MCPB Item No.: Consent Date: 06-28-18

Mateny Hill Road Property: Minor Site Plan Amendment No. 82016002A

Completed: 06-15-18

Figure 4 - As-built retaining walls Lots 19-25.

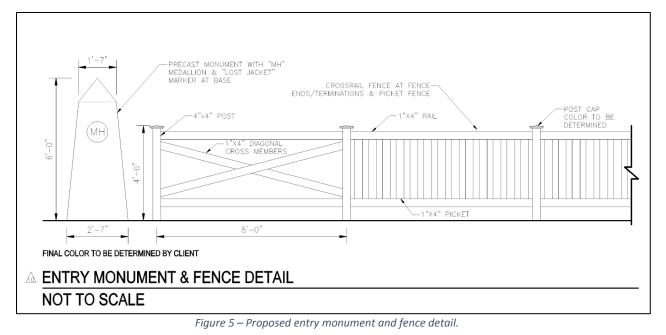
- Retaining walls heights reduced for the front yards of lots 19 through 25 with resulting heights ranging from approximately 0.2 ft. to 4.5 ft.
- Double-tiered retaining wall added to the front yards of lots 29 through 35 with approximate heights ranging from approximately 0.5 ft. 2.5 ft. (See Figure 4).
- New pre-cast monument marker sign (See Figure 5).
- New 4-ft. cross-rail decorative picket fence along Mateny Hill Road frontage (See Figure 5).
- Picnic tables with ADA accessible picnic table and ADA accessible stone path added.
- Minor landscaping revisions due to public utility changes required by dry utility companies and availability of healthy planting materials, minor surface grading modifications and trench drain additions due to field conditions, street tree revisions due to Department of Permitting Services comments regarding overhead wires.

- The retaining wall behind lots 25 through 19 is reduced in height by approximately one foot reducing the impact of the wall and maintenance needs. The resulting height adequately accommodates the elevation change and provides a safe transition between the street and private yard area.

- 1 Site Plan Amendment
- 2 MCPB Resolution No. 16-039 for Site Plan 820160020

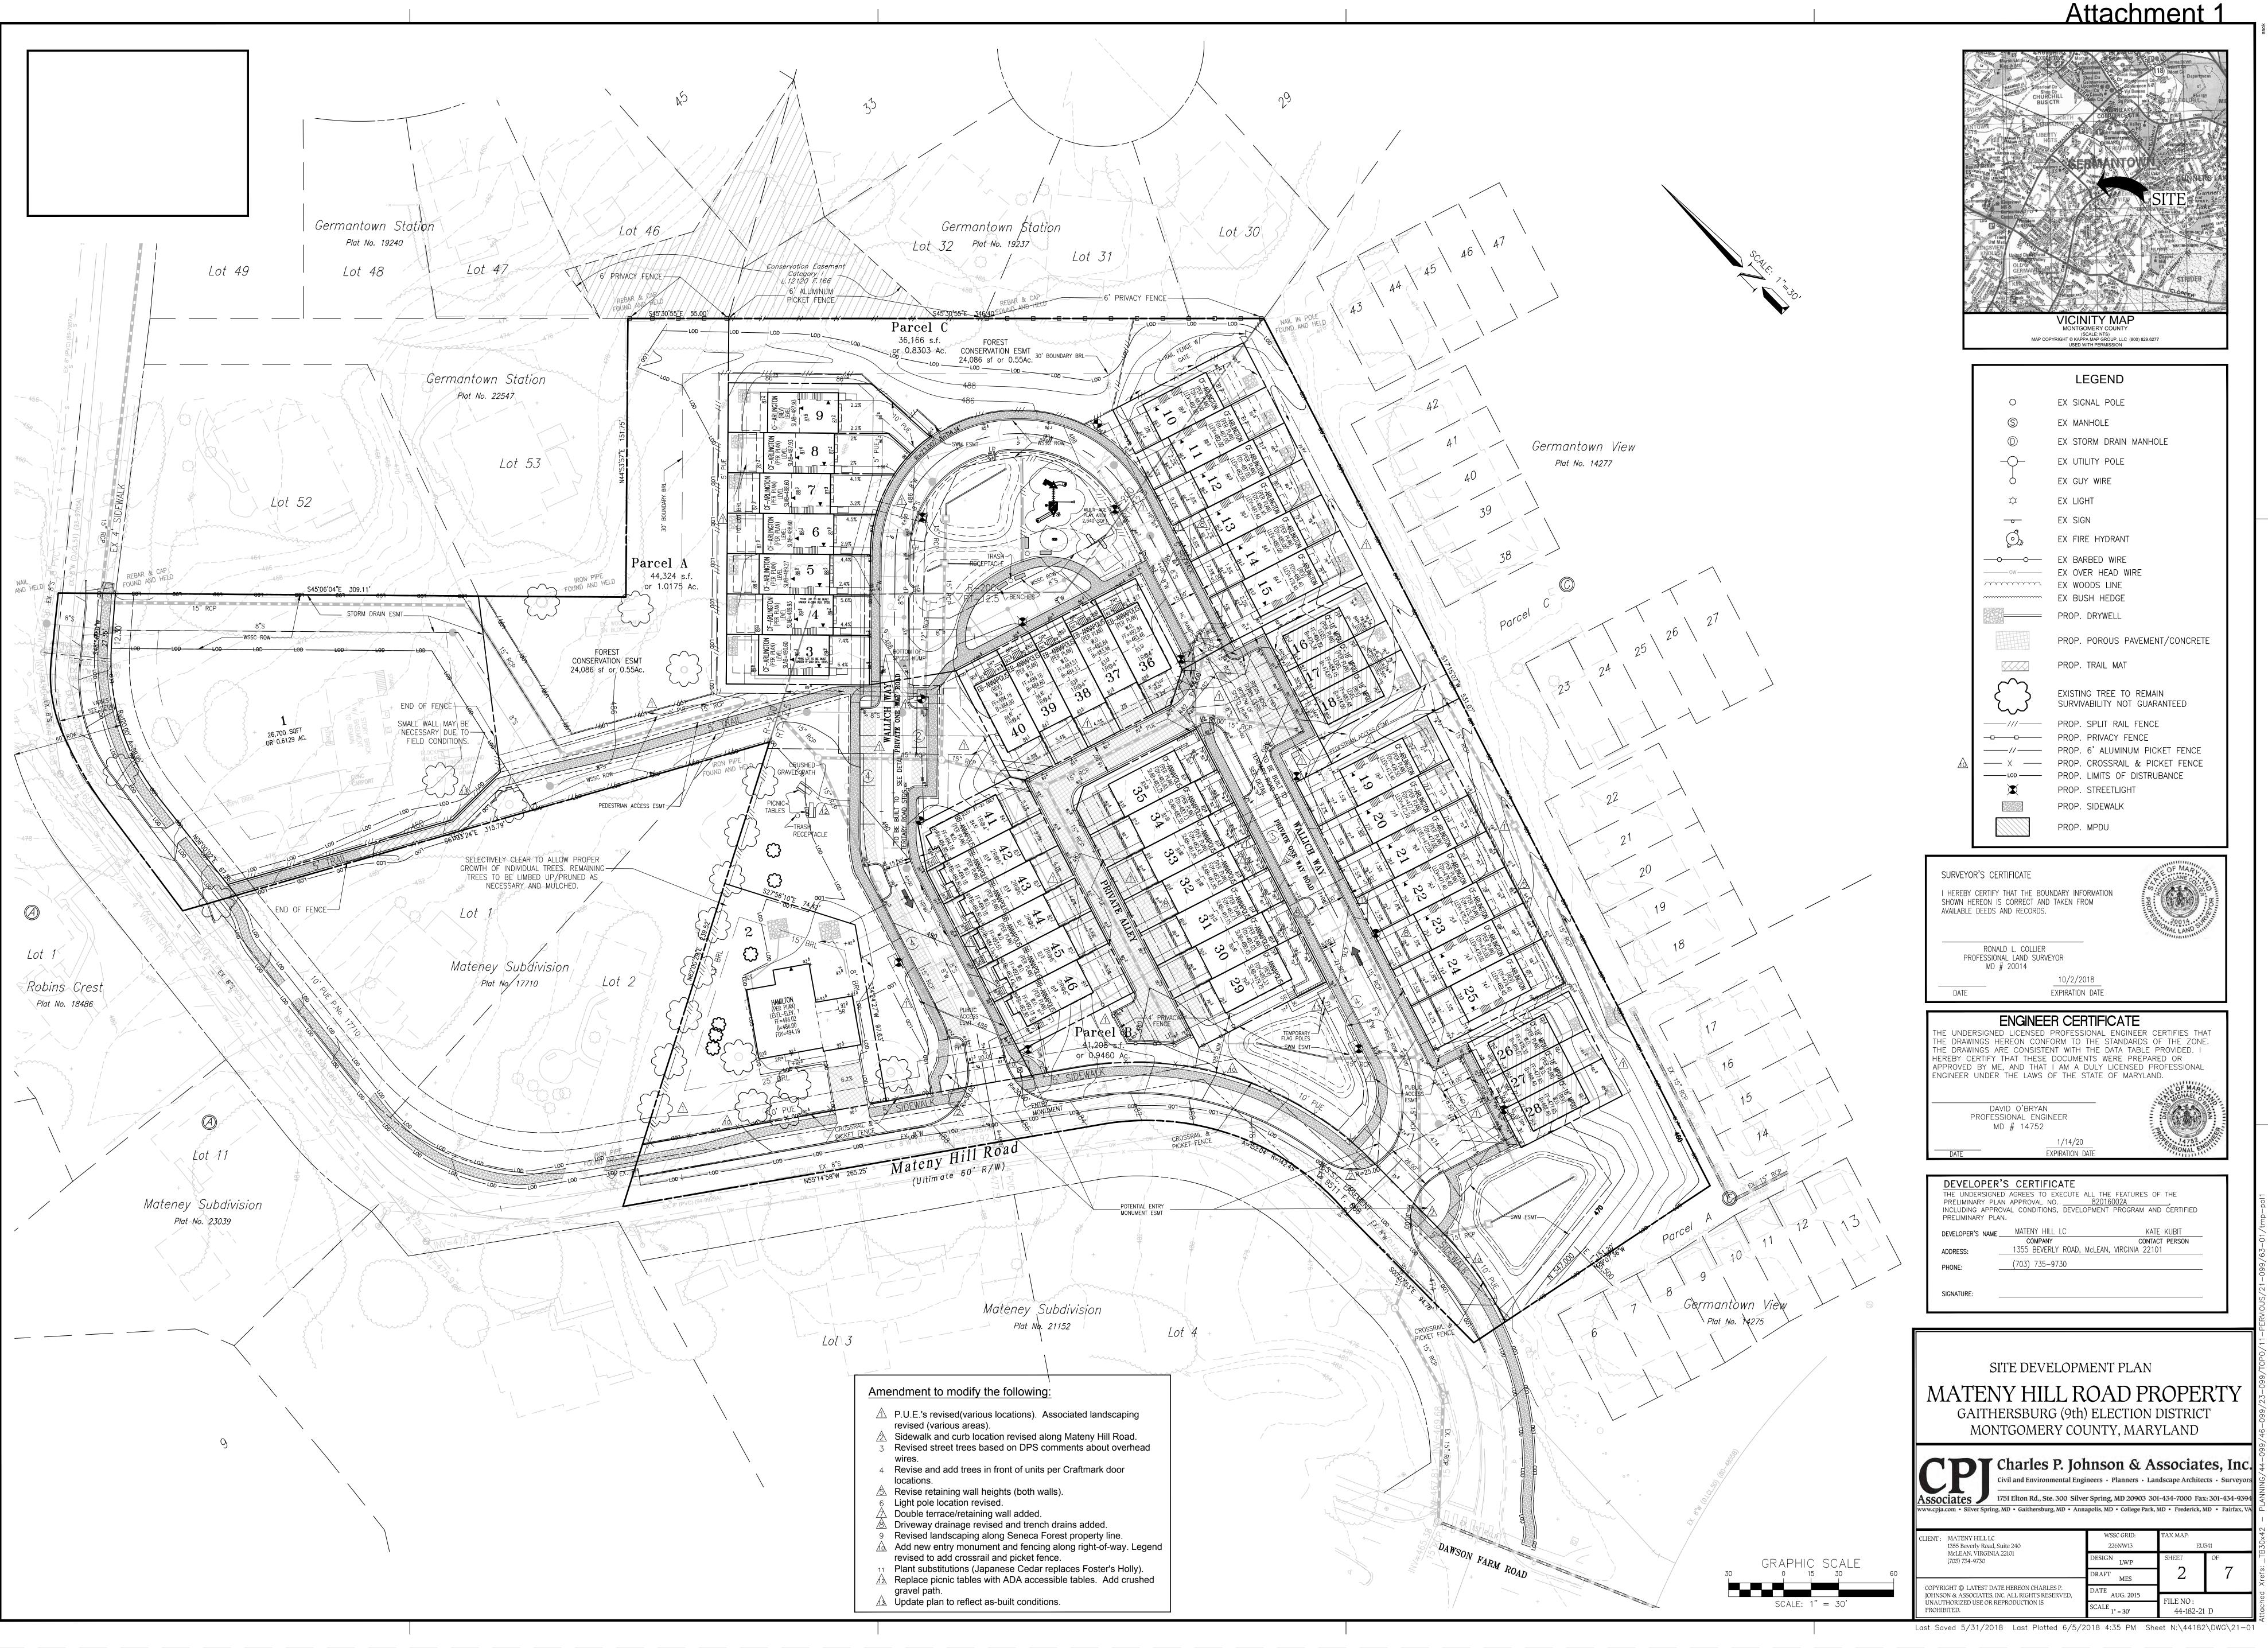
The location of buildings and structures are adequate, safe and efficient and comply with the previously approved site plan. The proposed changes to structures consist of retaining wall modifications, new retaining walls, new decorative fence, and a new monument sign as follows:

- The double terrace retaining wall added in front of lots 29 through 35 will not negatively affect the pedestrian realm along the sidewalk due to its low height. It also efficiently provides additional landscaping which contributes to the experience and appearance. The resulting height adequately accommodates the elevation change and provides a safe transition between the street and private yard area.

- The decorative fence along the Mateny Hill Road frontage is in keeping with other fences found in and near the historic district along Mateny Hill Road. The fence helps to define and identify the subdivision and contributes to the sense of place.

- The monument sign is 6 ft. tall by 2 ft. 7 in. wide and made of pre-cast concrete, or similar material. Its location at the entrance adequately identifies the development and contributes to a sense of place for this subdivision.

Staff recommends approval of the Site Plan Amendment No. 820160020A with all site development elements shown on the latest electronic version as of the date of this Staff Report submitted via ePlans to the M-NCPPC. All previously approved plans, findings, and conditions of approval remain in full force and effect, except as modified herein by the following conditions:
